Re: Landfill Expansion
White Oaks Sanitary Landfill
Haywood County, NC

RE: Design Hydrogeologic Report REV 1 Addendum 1 for the White Oak Landfill, Haywood County, NC

Ref: Haywood County Permit Renewal

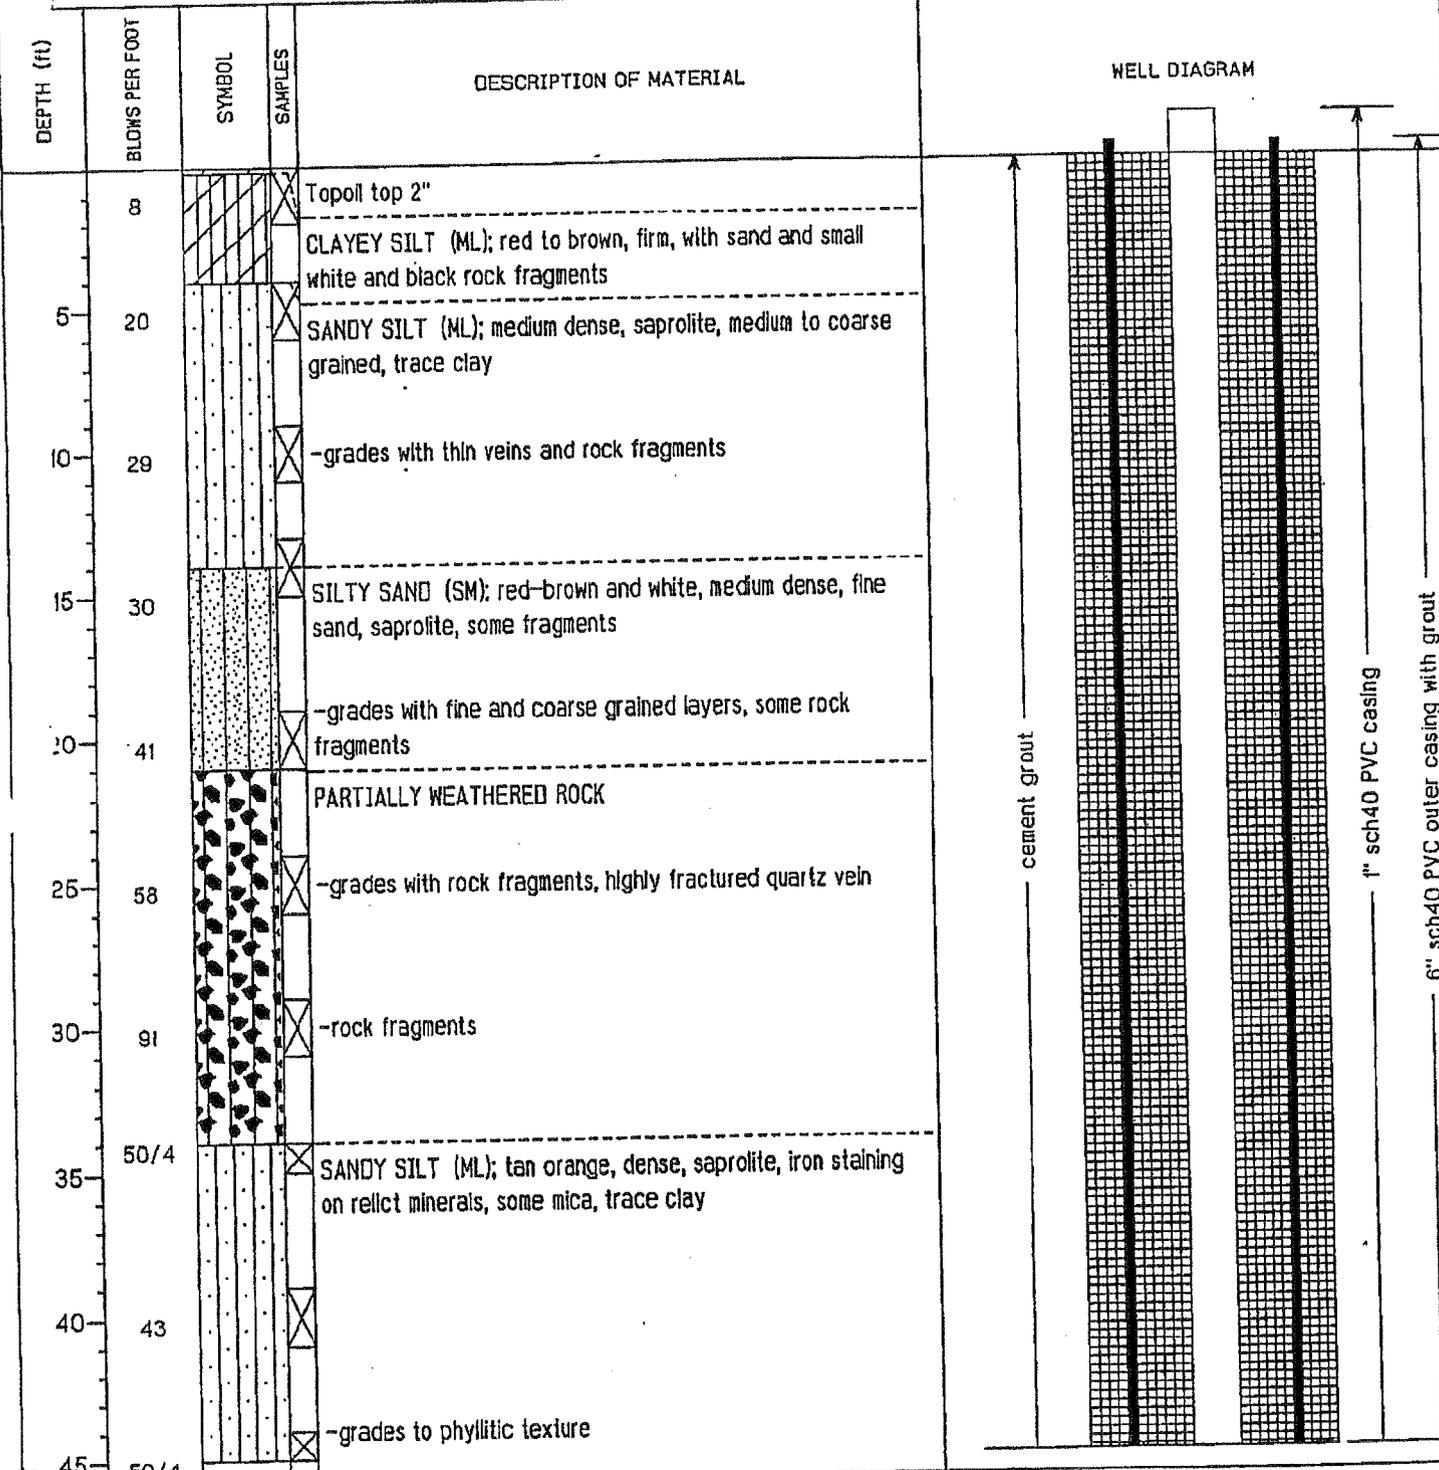
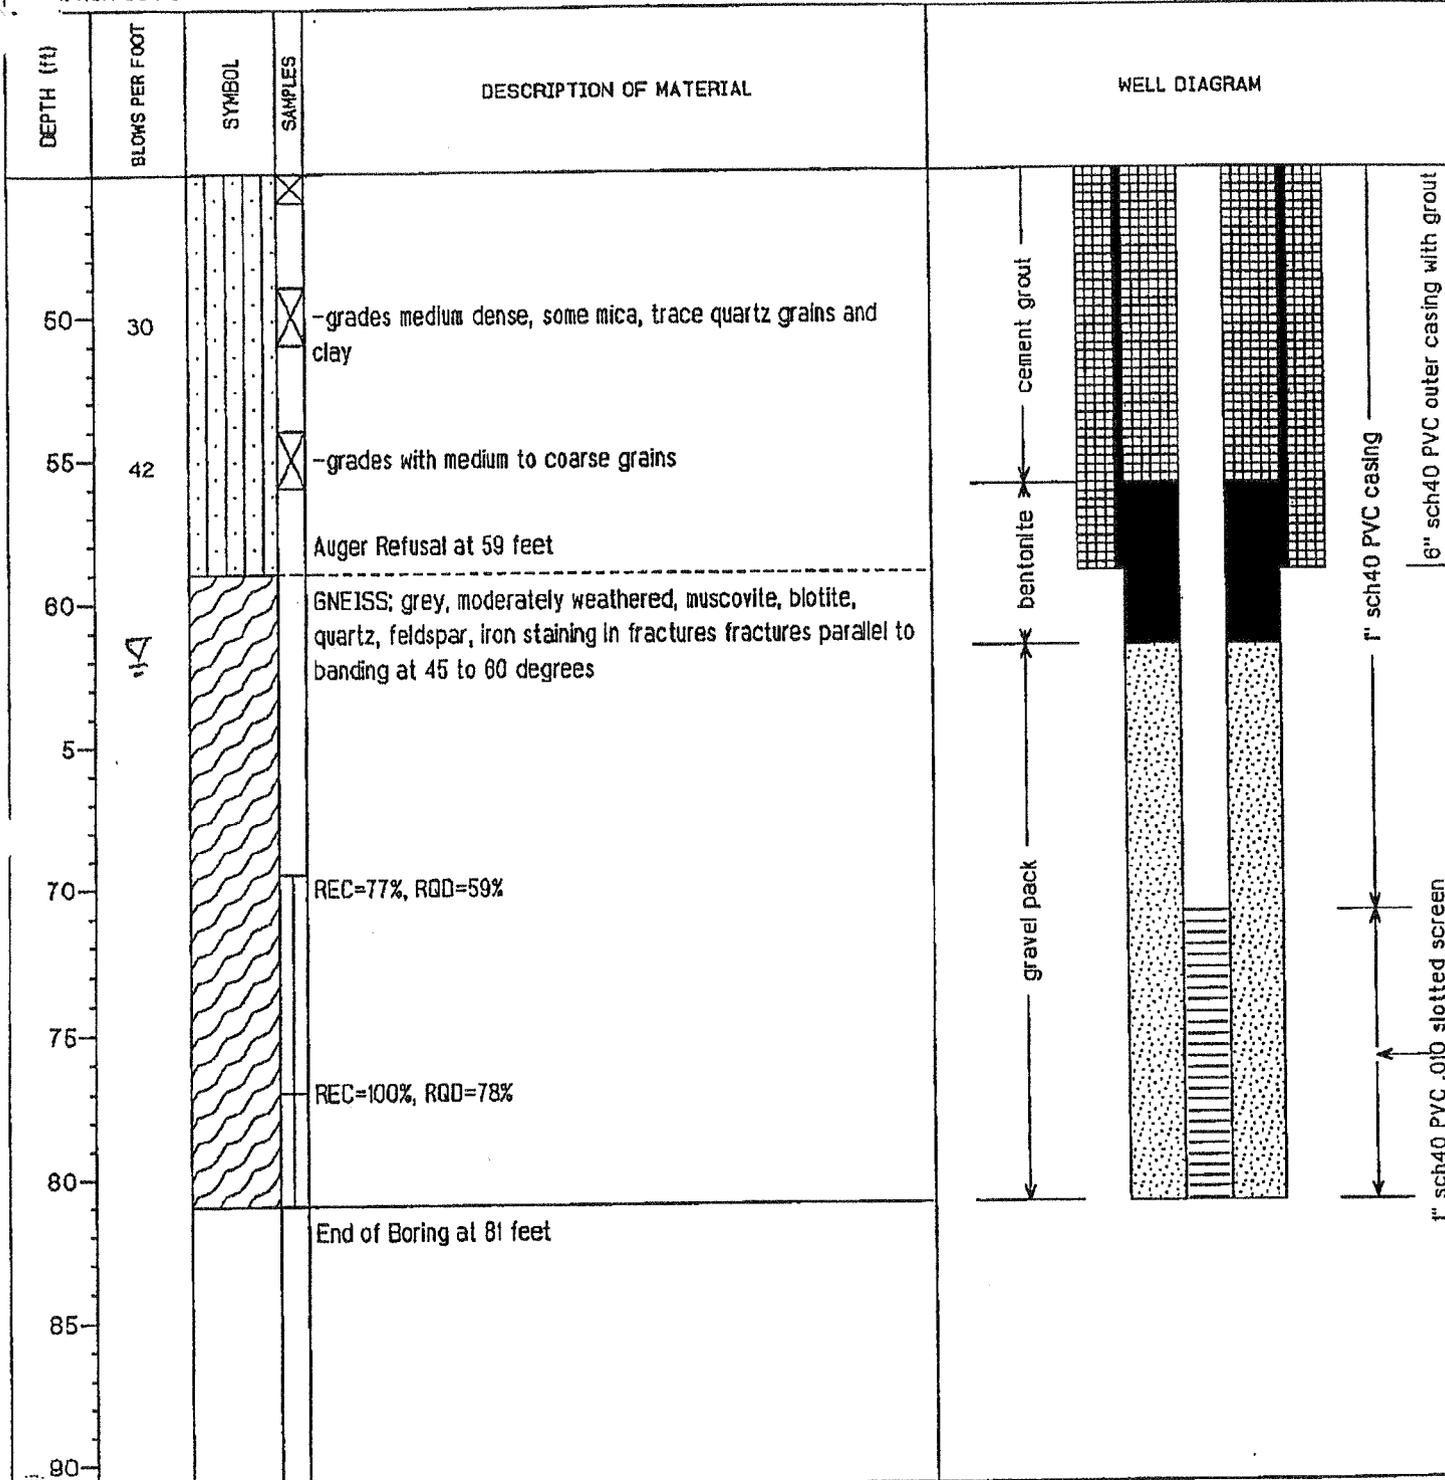
On Figure 3, you will see that the potentiometric surface mimics the ground surface when crossing the valley. This new figure includes information from borings that Municipal Engineering installed on the western side of the valley (P-4, P-10, and P-12). Although the potentiometric map for this single event does not show any spring relief in the valley, spring relief is probable in the valley from B-113 northwards.

*why is
springs relief
not reflected
in map*
